ADDENDUM #1

6450 Five Points Parkway (Wesco Building)

ADDENDUM #1 FOR INVITATION TO BID

The purpose of this addendum is to clarify questions raised during the walkthrough. All specifications listed in the original Invitation to Bid are still applicable for this project.

GAF	WALL/CURB FLASHING WITH TERMINATION BAR			LEGEND
	DRAWING # 302A	THIS DETAIL APPLIES TO: ALL SYSTEMS	ISSUE / REVISION DATE 8/17/20	SCALE N.T.S.
				HATCHWORK FLEXSEAL® BONDING ADHESIVE

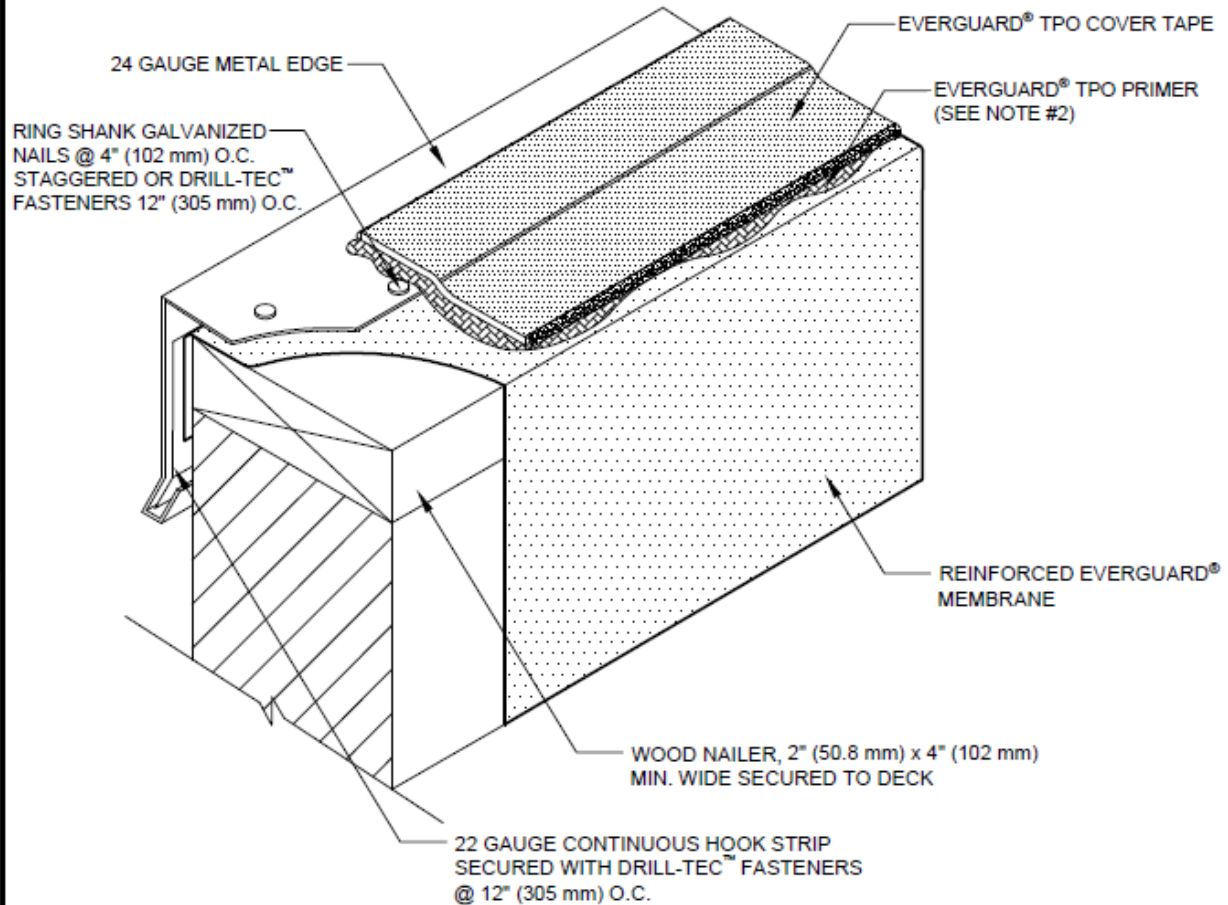
Additional Sheets Depicting Parapet and Curb Specs
